RAMP REPORT REGION 2 ADA 2026

Lawerence St., & Ingraham Lane,
Rockland

CR16769

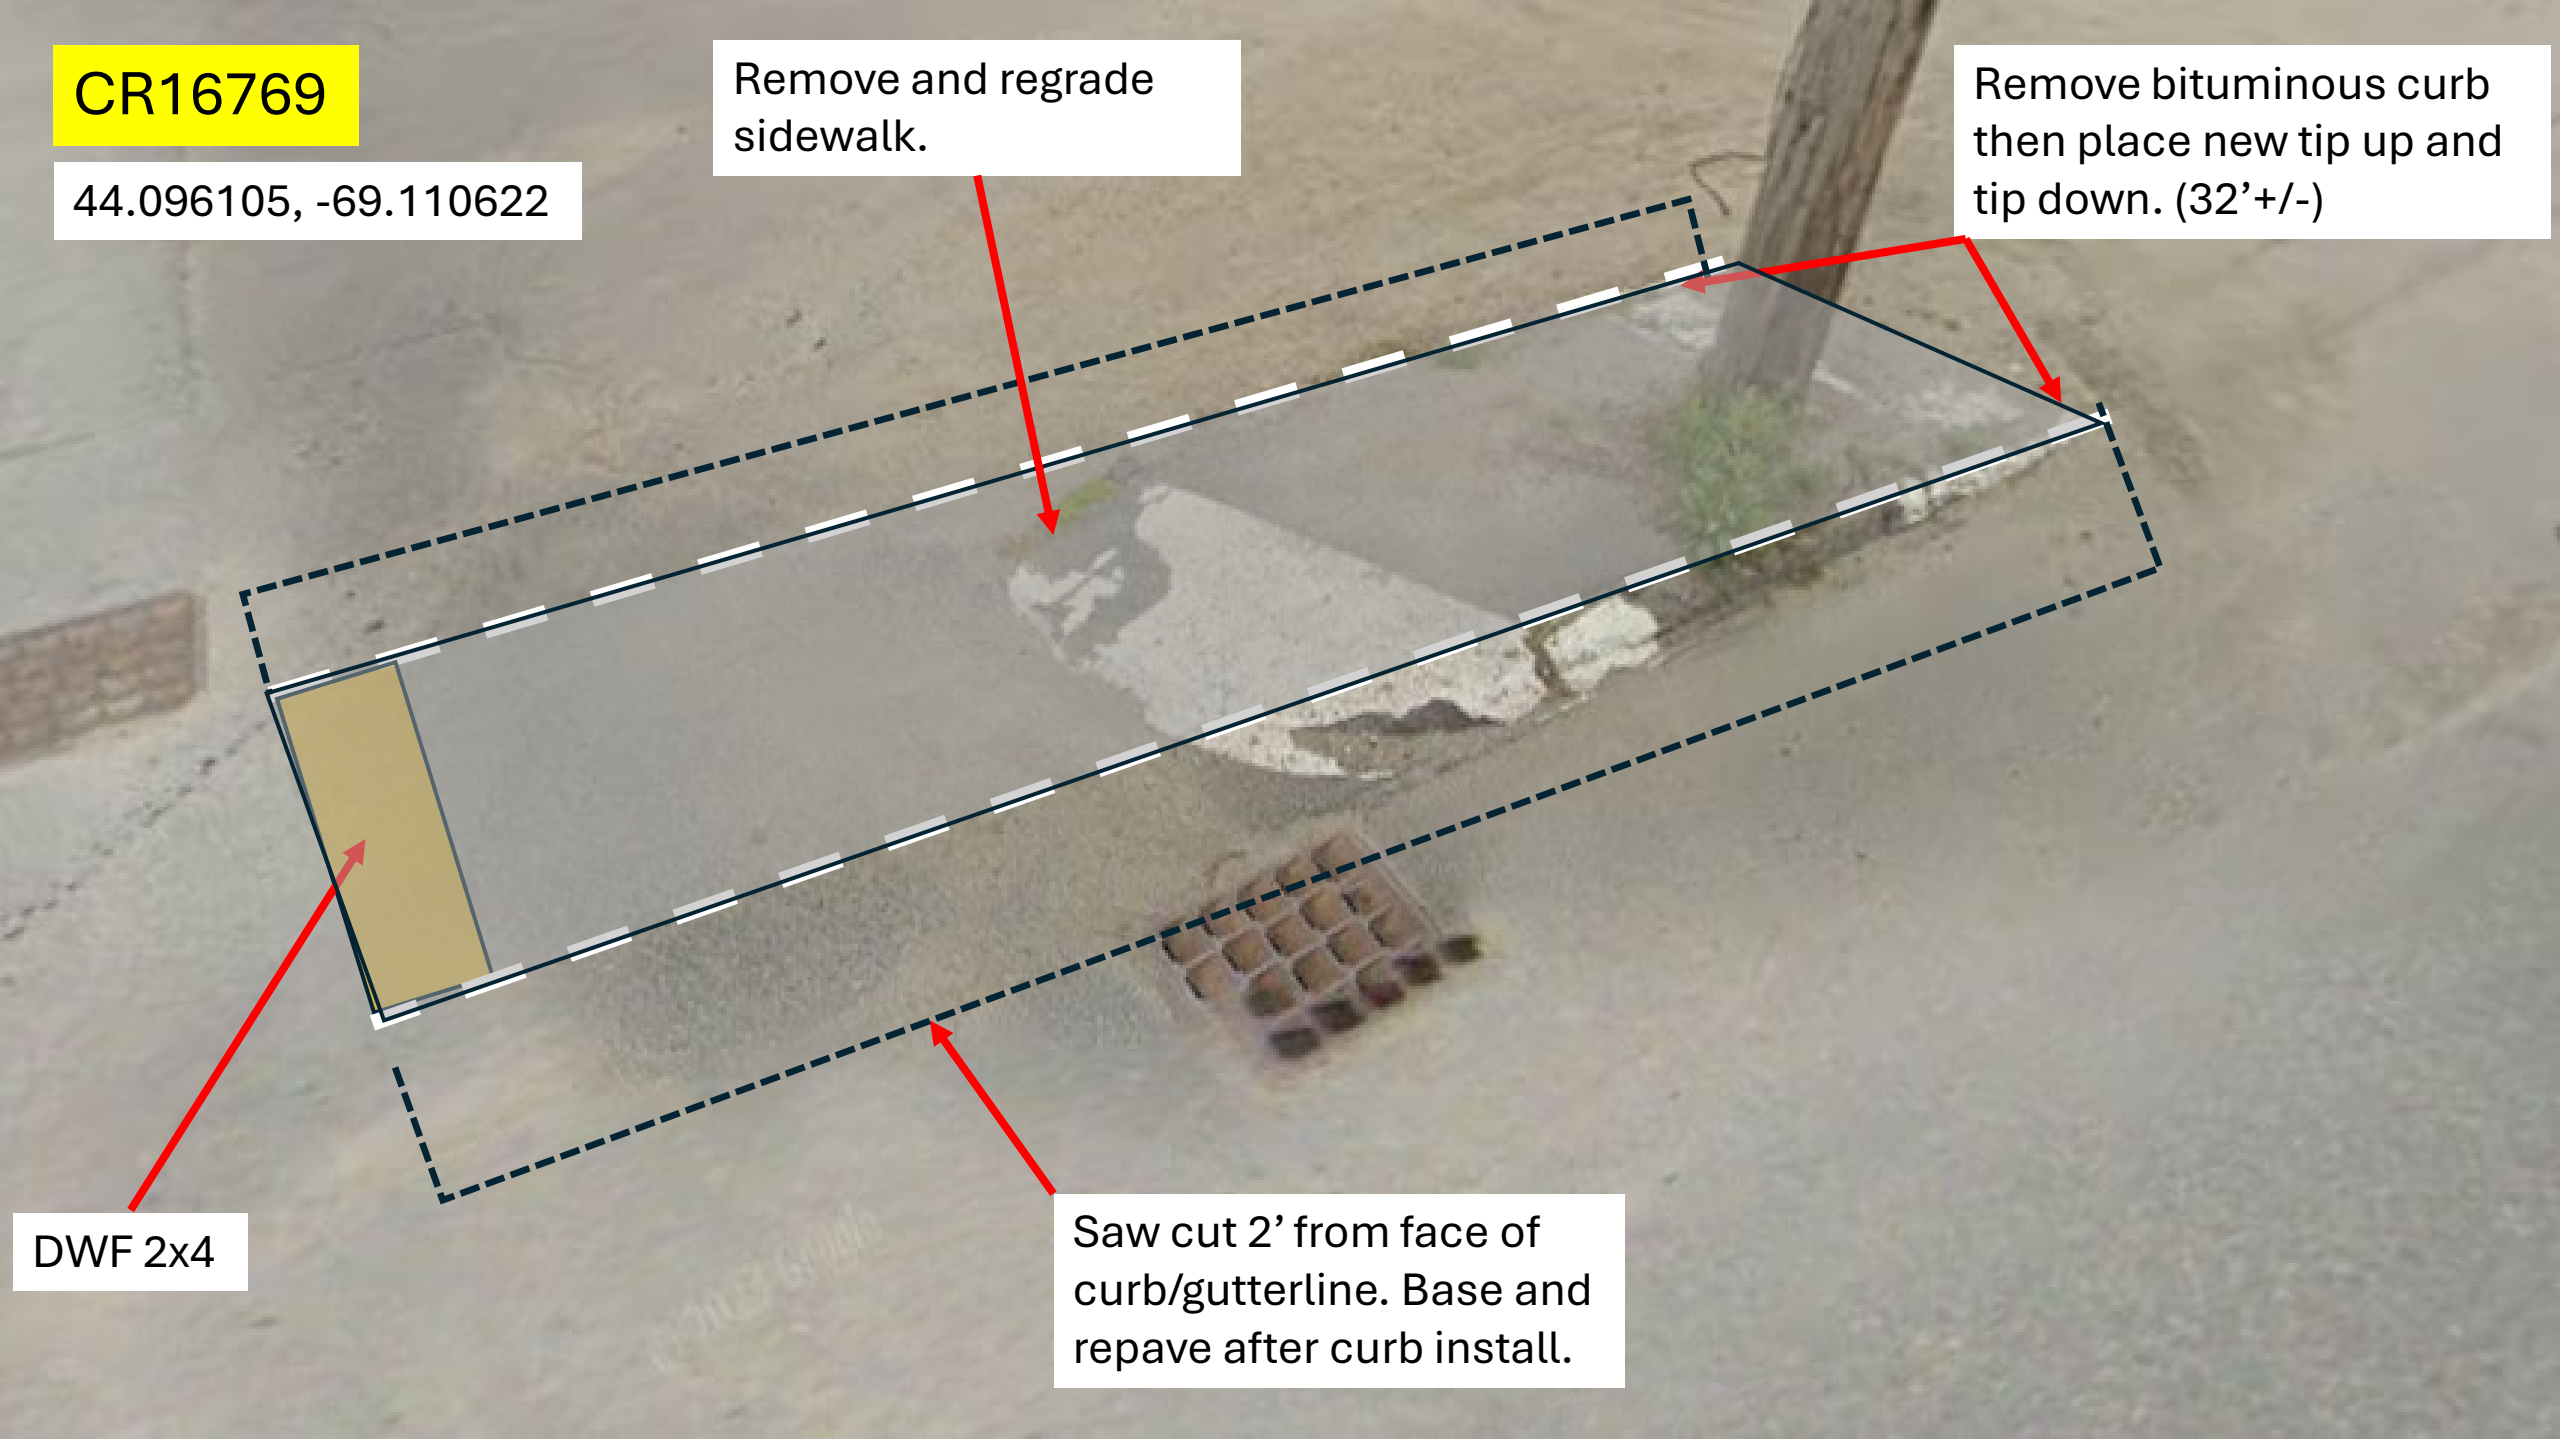
Remove and regrade sidewalk.

Remove bituminous curb then place new tip up and tip down. (32'+/-)

DWF 2x4

Saw cut 2' from face of curb/gutterline. Base and repave after curb install.

CR09031

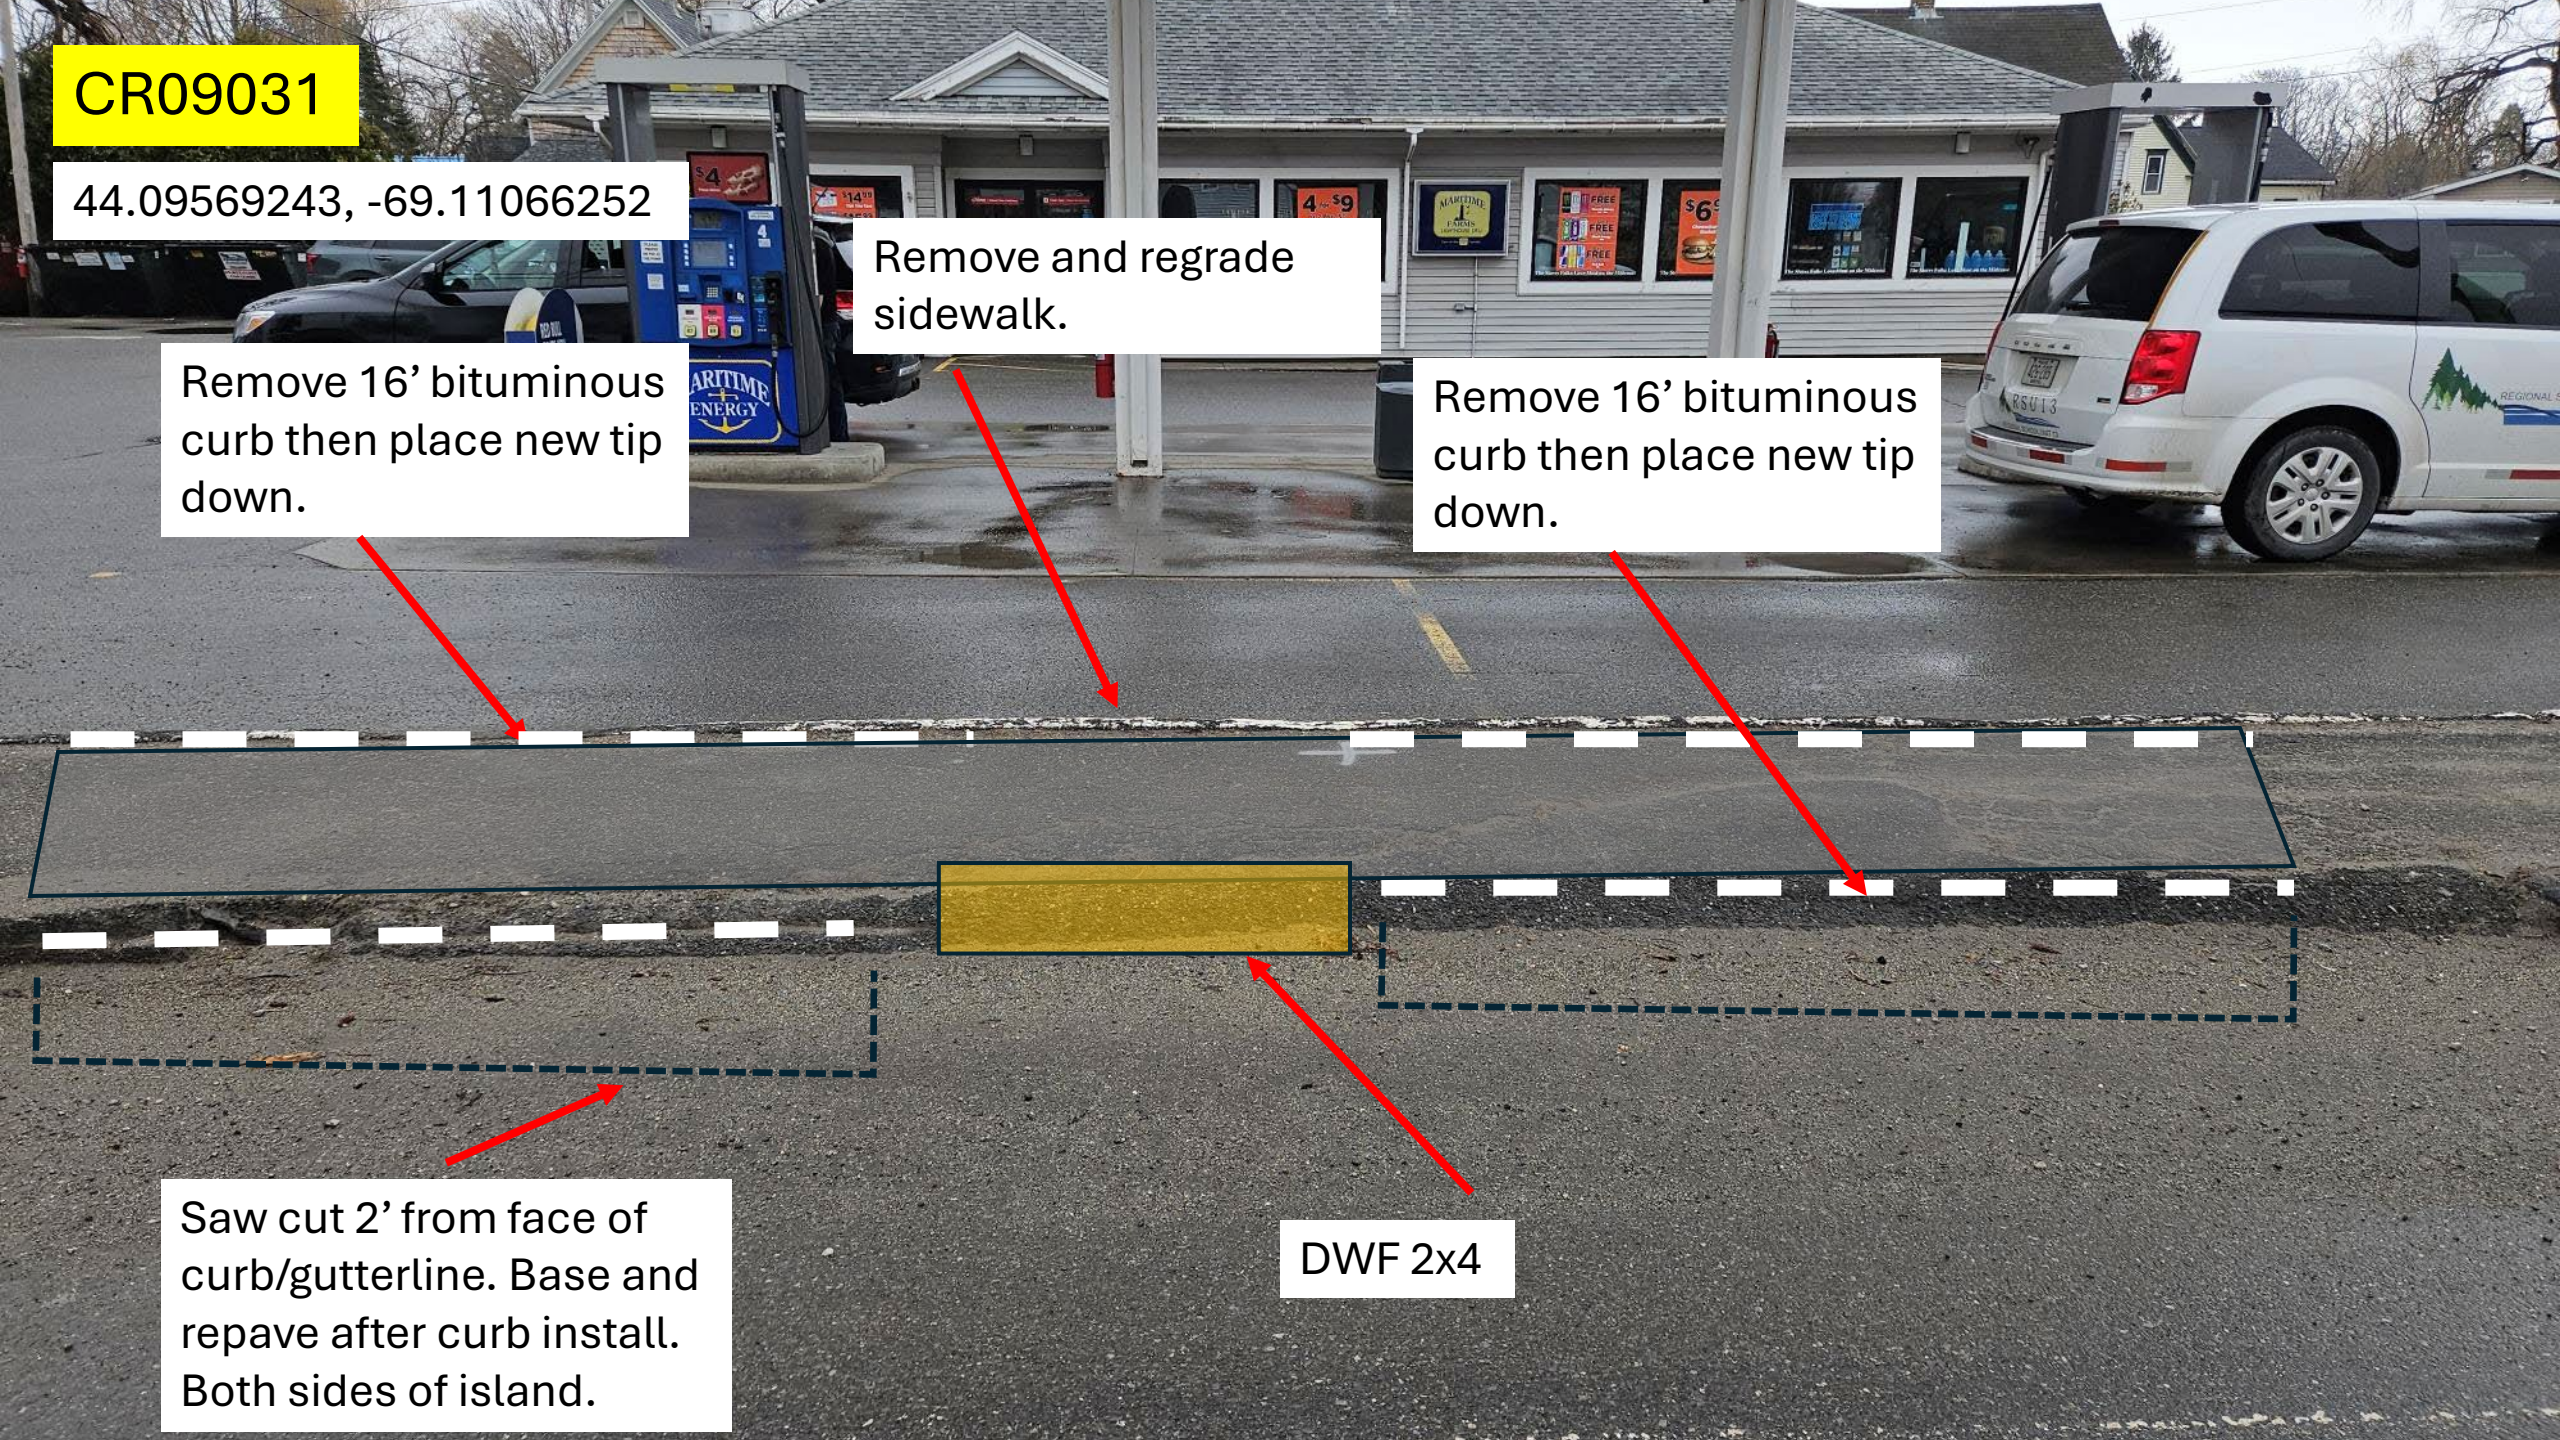
Remove and regrade sidewalk.

Remove 16' bituminous curb then place new tip down.

Remove 16' bituminous curb then place new tip down.

Saw cut 2' from face of curb/gutterline. Base and repave after curb install. Both sides of island.

DWF 2x4

CR09033

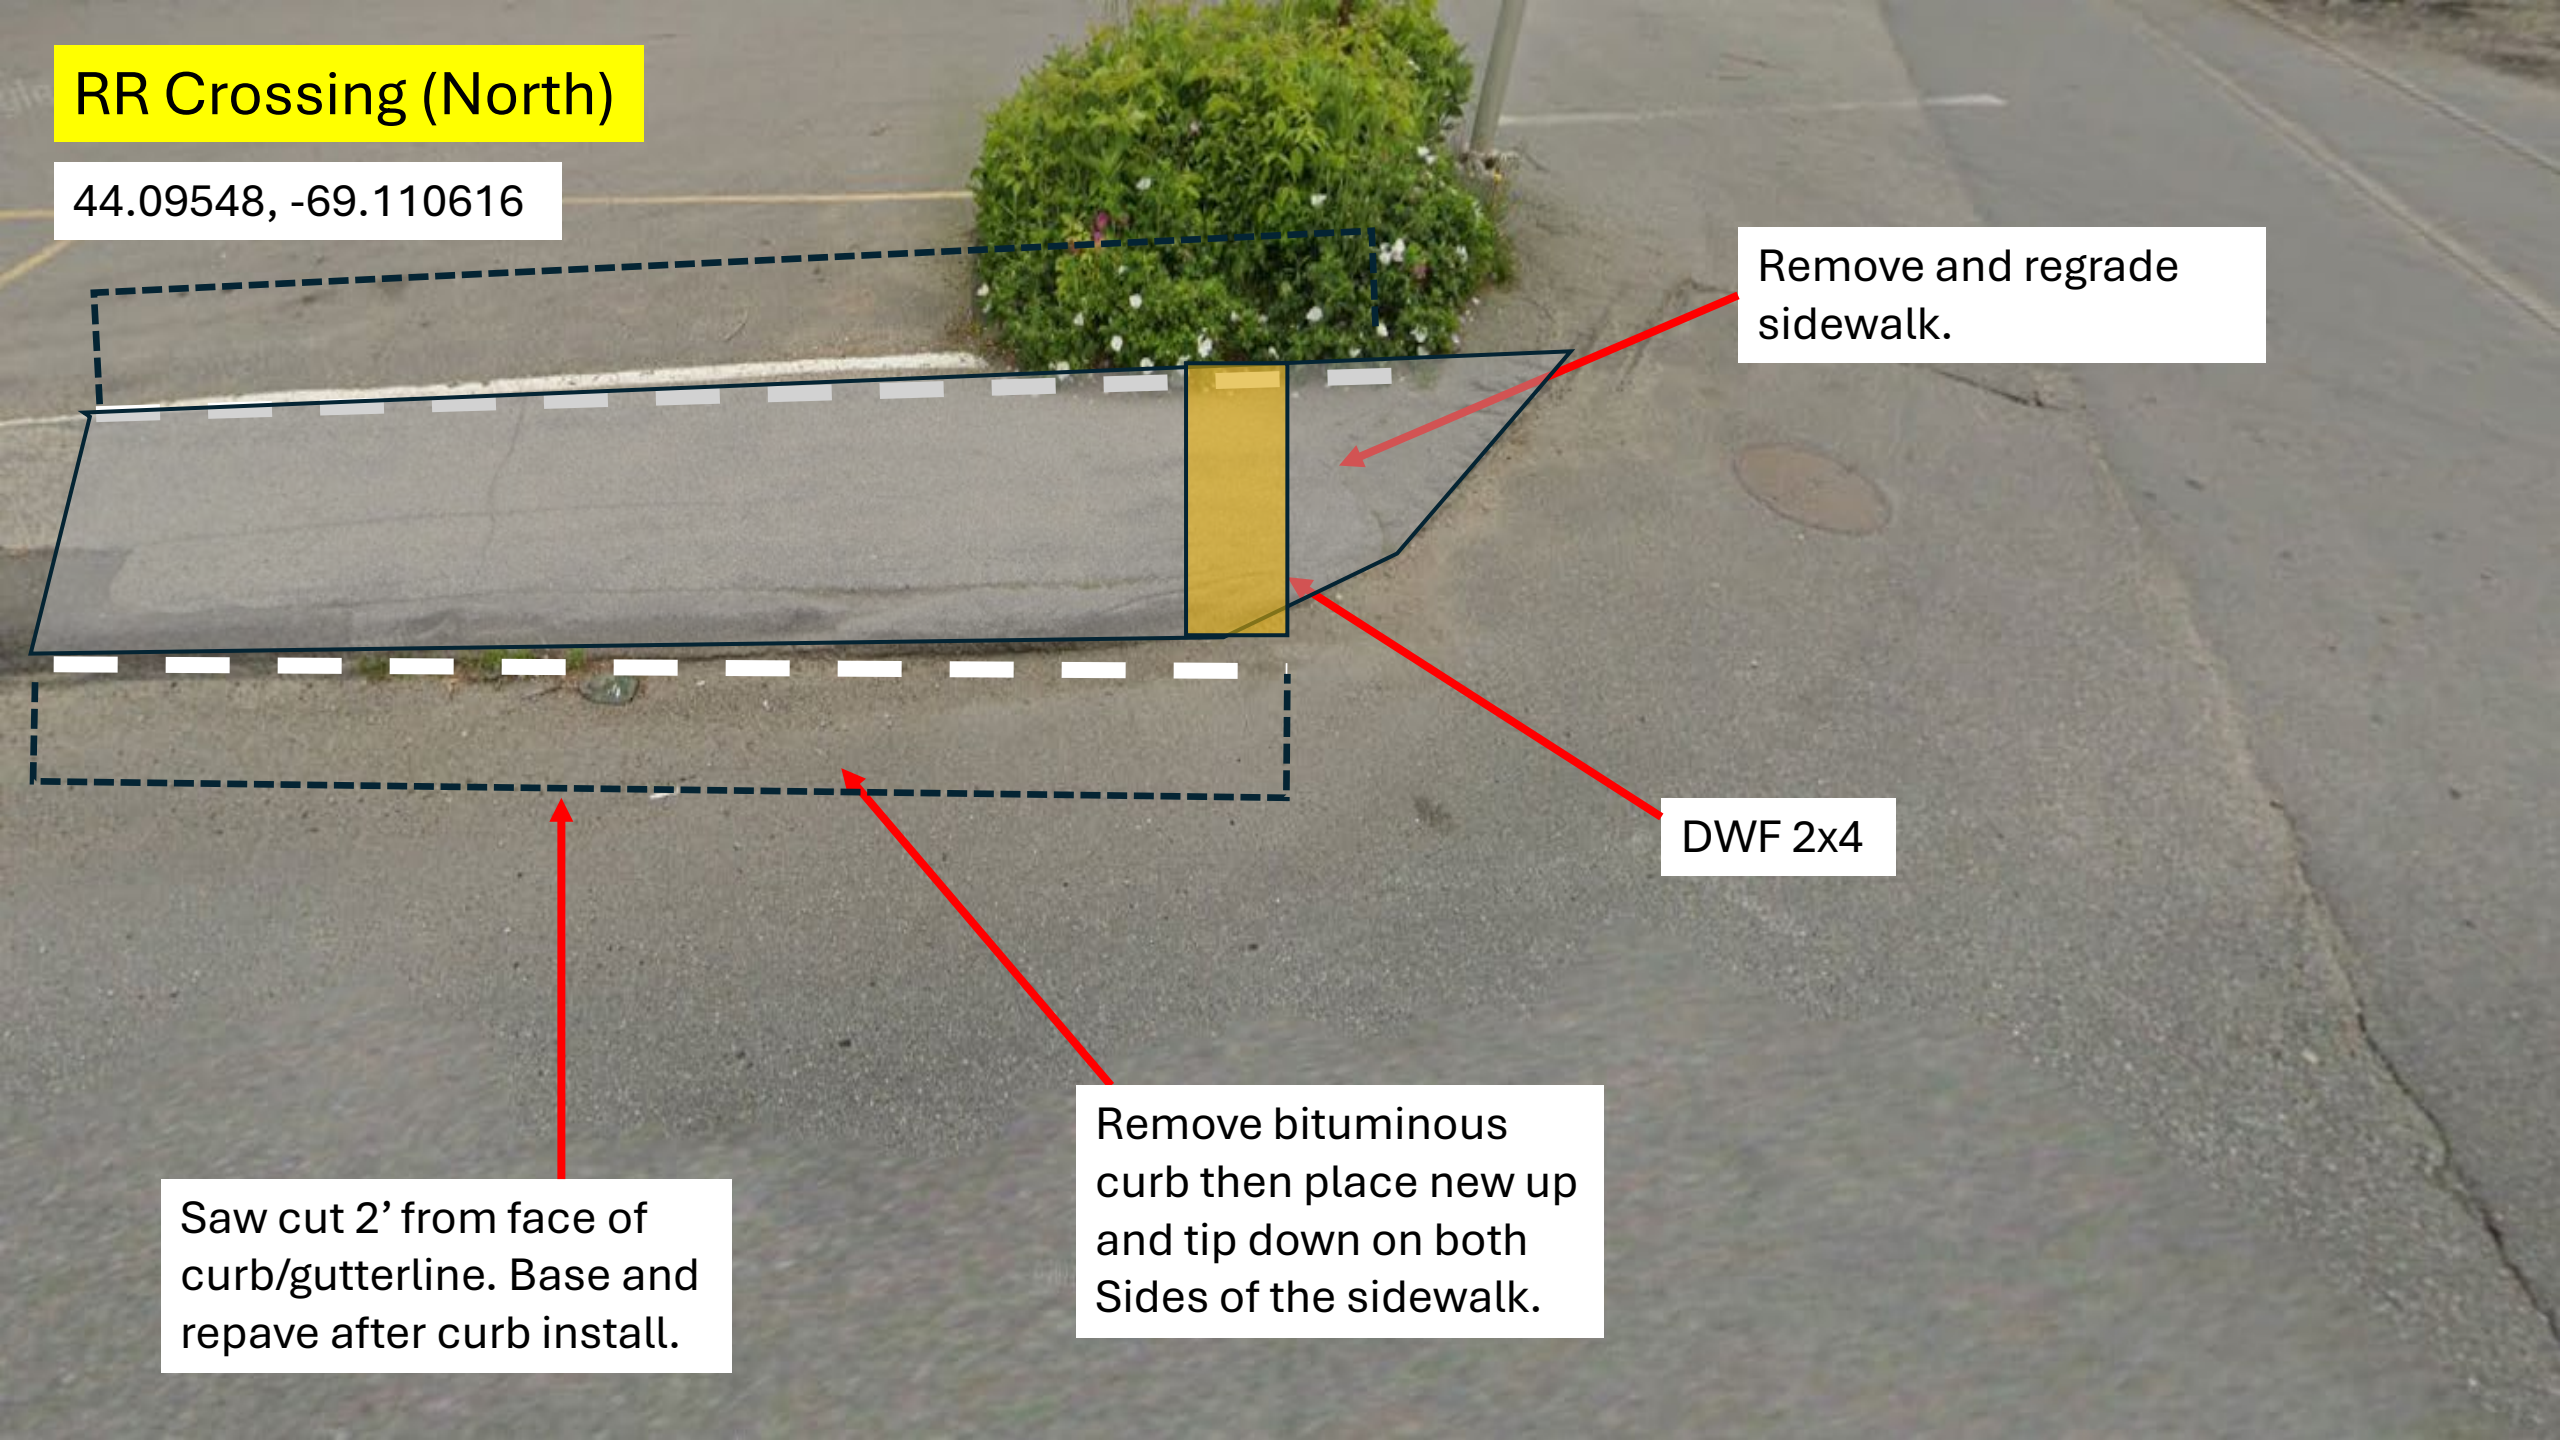
Remove and regrade
sidewalk.

Loam
and
seed.

DWF 2x4

Remove 16'+/-
bituminous curb then
place new tip down.

Saw cut 2' from face of
curb/gutterline. Base and
repave after curb install.
